# **ANP District Headquarters Facilities in Helmand and Kandahar Provinces Have Significant Construction Deficiencies Due to Lack of Oversight and Poor Contractor Performance**

## OFFICE OF THE SPECIAL INSPECTOR GENERAL FOR AFGHANISTAN RECONSTRUCTION

SIGAR Audit-11-3

**Photo 6: Crumbling Concrete Stairs of Different Heights at Garm Ser Site**

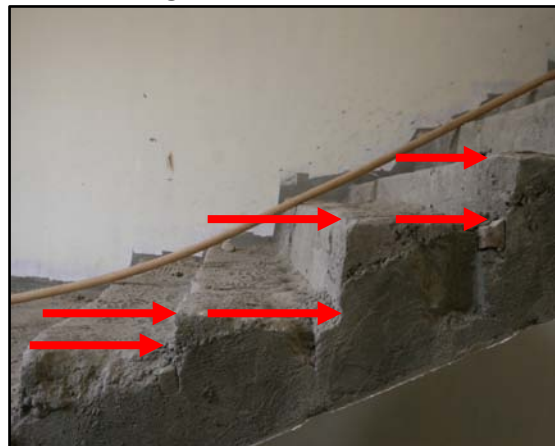
Our inspections found concrete stairs at facilities that were poorly formed, improperly constructed, and comprised of poor concrete with questionable strength. The cast-in-place concrete stairs at all six sites did not conform to the construction drawings either structurally or architecturally. The plans indicated that the stairs were intended to be monolithically cast-in-place reinforced concrete with a curved metal wearing strip embedded at the edge of each step and sealed with a chemical sealant. The treads and risers of the stairs we observed were of varying dimensions. We also observed that the steps were formed separately from the sloped base of the stairs, creating a weakened section that could fail under normal use. Photographs 5 and 6 shows poorly consolidated concrete and improperly formed stairs at Garm Ser.
